Project	<b>IEEE 802.16 Broadband Wireless Access Working Group</b> < <a href="http://ieee802.org/16">http://ieee802.org/16</a> >
Title	<b>Amendment to Idle Mode Service Primitives</b>
Date Submitted	<b>2007-03-<del>1509</del></b>
Source(s)	Jeehyeon Na, Jaesun Cha, JungMo Moon and Sangho Lee <a href="mailto:jhna@etri.re.kr">jhna@etri.re.kr</a> ETRI 161 Gajeong-dong, Yuseong-gu Daejeon 305-700 Korea
Re:	Contribution on comments to IEEE 802.16g/D8
Abstract	Re-definition of Idle mode service primitives in section 14.2.4.2
Purpose	Adoption
Notice	This document has been prepared to assist IEEE 802.16. It is offered as a basis for discussion and is not binding on the contributing individual(s) or organization(s). The material in this document is subject to change in form and content after further study. The contributor(s) reserve(s) the right to add, amend or withdraw material contained herein.
Release	The contributor grants a free, irrevocable license to the IEEE to incorporate text contained in this contribution, and any modifications thereof, in the creation of an IEEE Standards publication; to copyright in the IEEE's name any IEEE Standards publication even though it may include porti

Figure 479—Subscriber mode transition diagram at NCMS ([on BS or MS side](#))

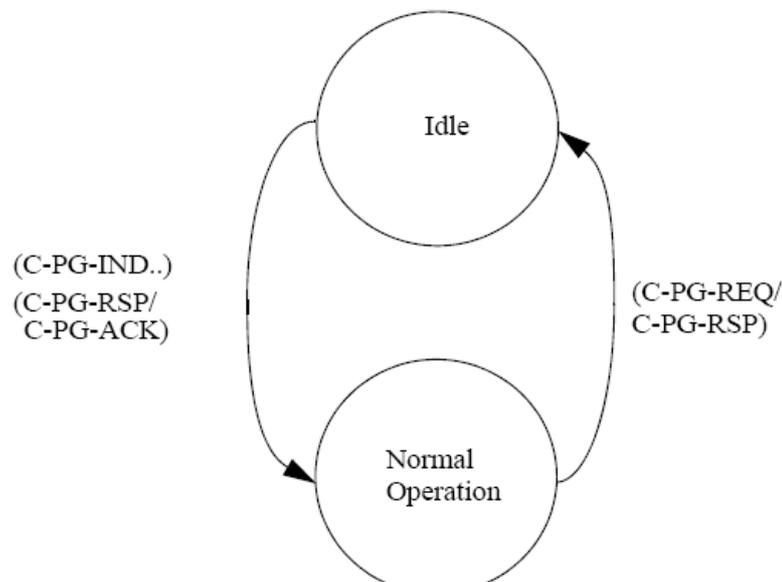
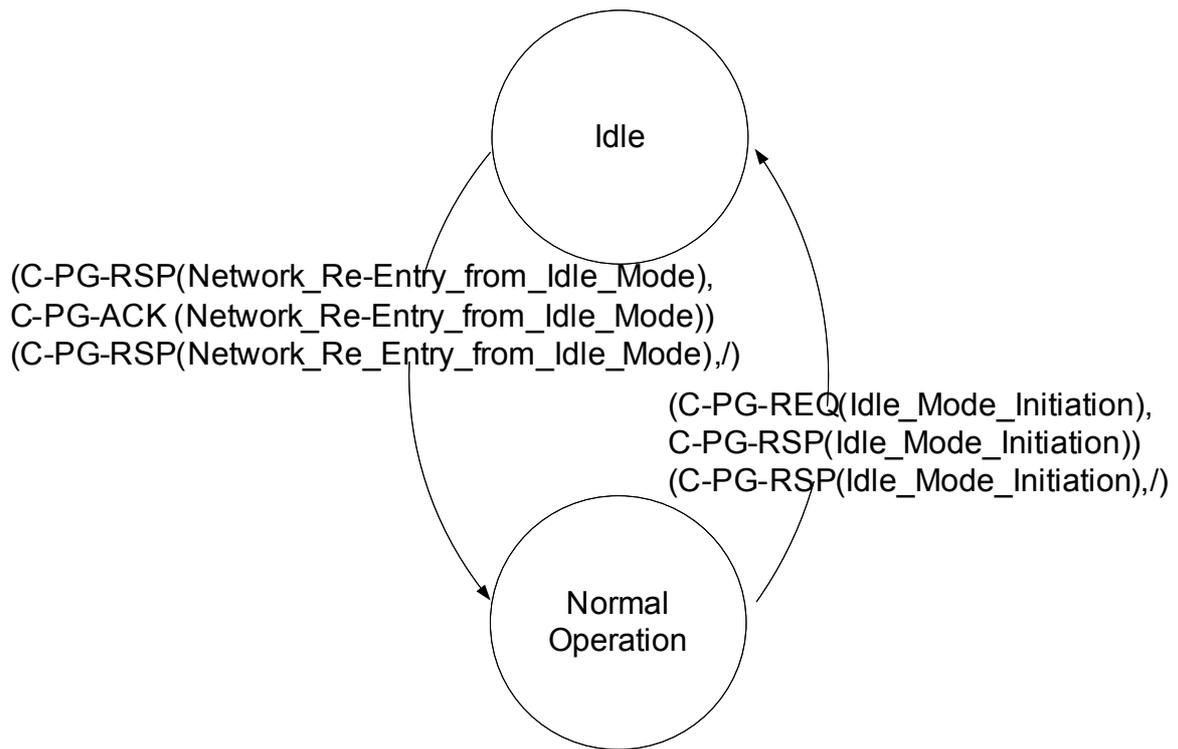
Subscriber mode management is described as informative in section 14.2.4 and it is managed at an MS, a BS and an NCMS. Figure 479 which shows subscriber mode transition diagram at an NCMS is not clear whether for an NCMS on a BS and an MS side or not.

Therefore, we clarify figure 479 and the related texts in order to be used both NCMS at an MS and a BS side.

Figure 479 shows Subscriber Mode transition diagram at the NCMS with service primitives related with the Subscriber Mode transition. Subscriber Mode transition from Normal Operation to Idle Mode is performed by exchanging C-PG-REQ and C-PG-RSP between ~~a BS~~ an 802.16 entity and the NCMS after successful DREG-REQ message from the MS with De-Registration Request Code=0x01 or DREG-CMD message from the BS with Action Code = 0x05, where C-PG-REQ and C-PG-RSP are defined in 14.2.4.2.1 and 14.2.4.2.2, respectively. Subscriber Mode transition from Idle Mode to Normal Operation is initiated after exchanging ~~C-PG-IND~~, C-PG-RSP, and C-PG-ACK between an 802.16 entity ~~BS~~ and the NCMS, where ~~C-PG-IND~~, C-PG-RSP, and C-PG-ACK are defined in ~~14.2.4.2.4~~, 14.2.4.2.2, and 14.2.4.2.3, respectively.

Figure 480 – Idle mode initiation (NCMS on the MS side)

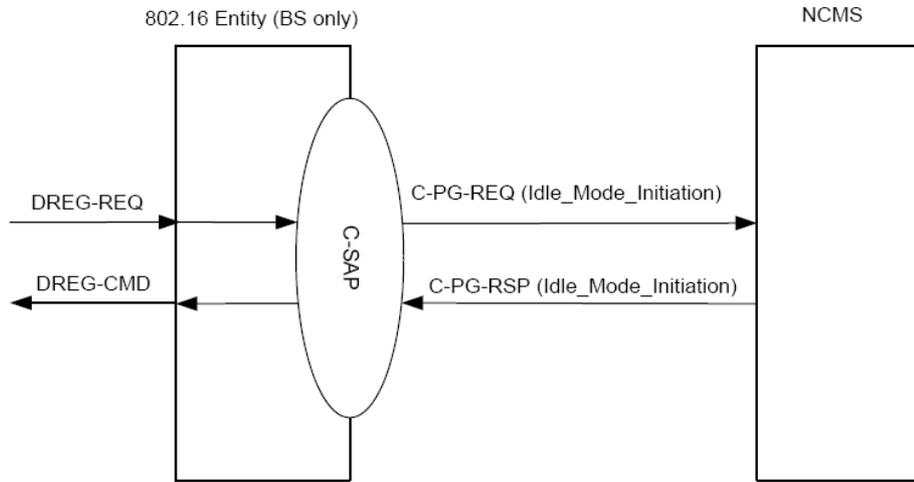
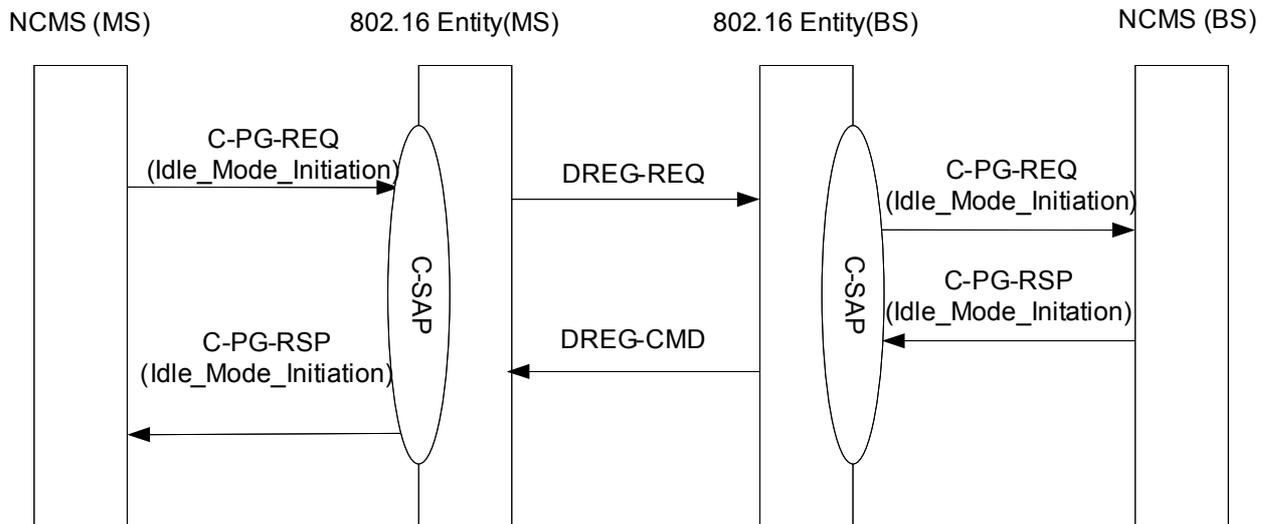
Therefore, we propose to change figure 480, 482, 483 to the figures which are included the service primitives between an 802.16 entity (MS) and an NCMS on the MS side and modify the related service primitives parameters in this contribution. And we also correct some editorial texts.

[Change the figure 480 and its title to as follows]

Figure 482- Paging Announcement

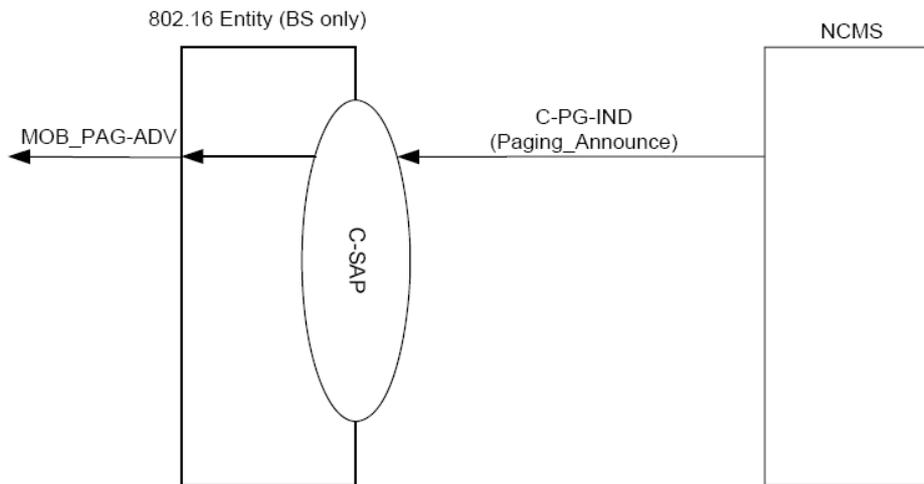
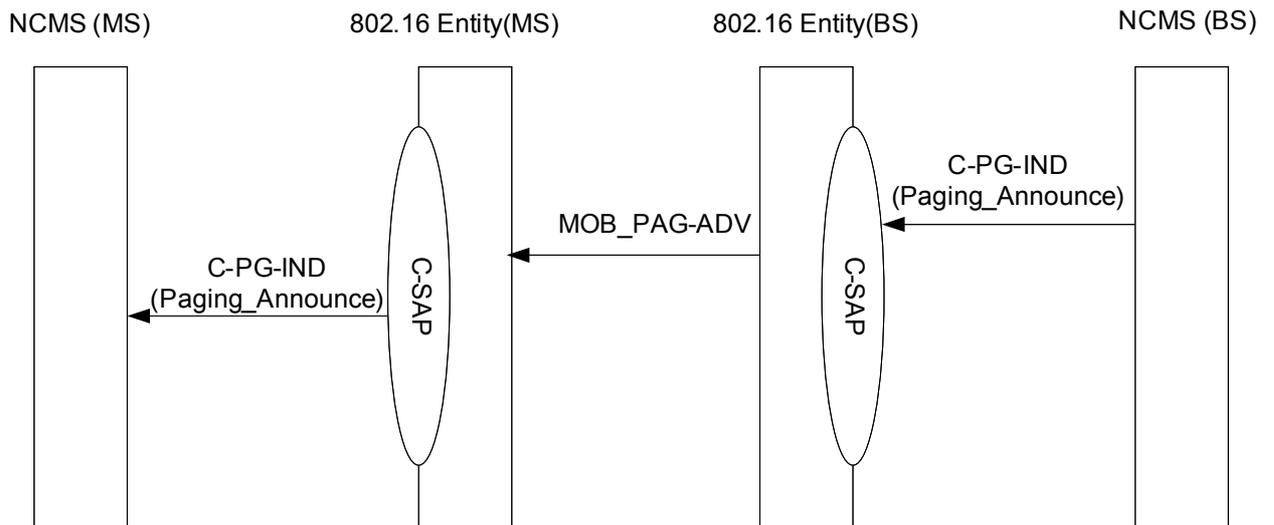
[Change the figure 482 to the following figure Section 14.2.4.2 ]

Figure 483- Network re-entry from Idle mode primitives

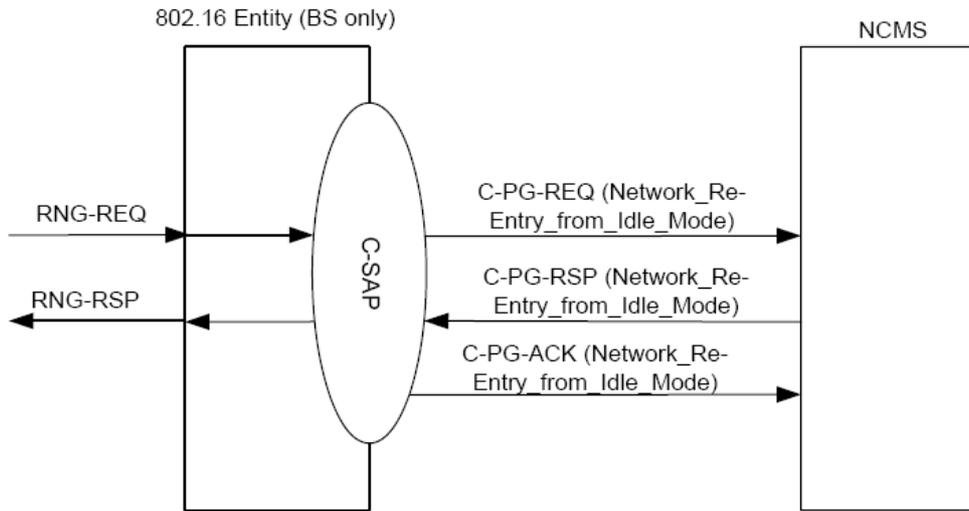
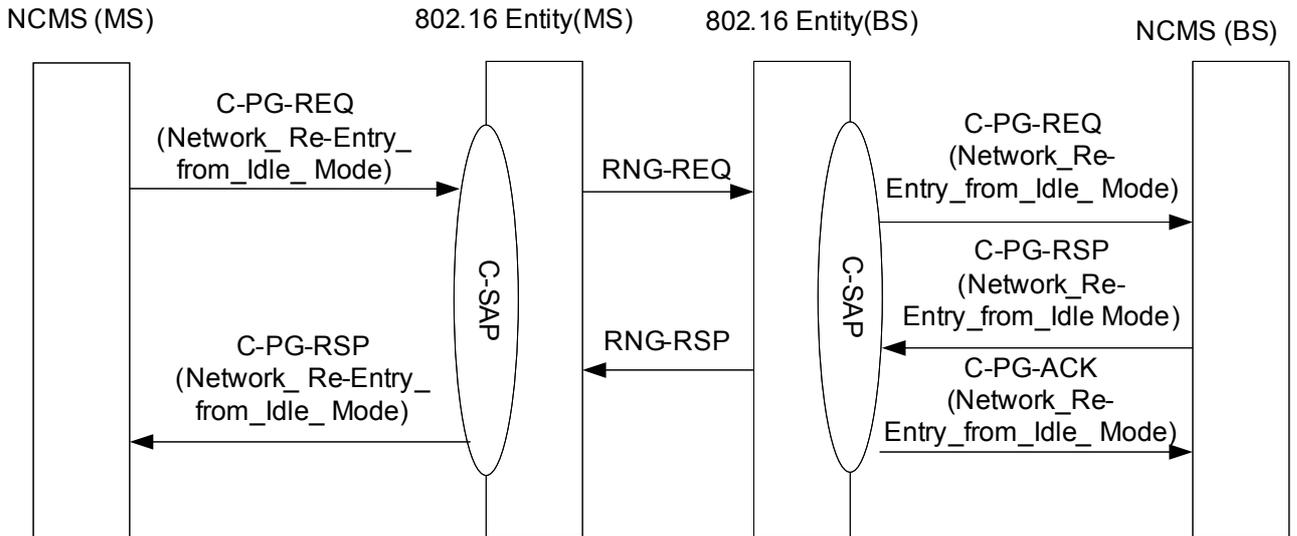
[Change the figure 483 to the following figure in 14.2.4.2]
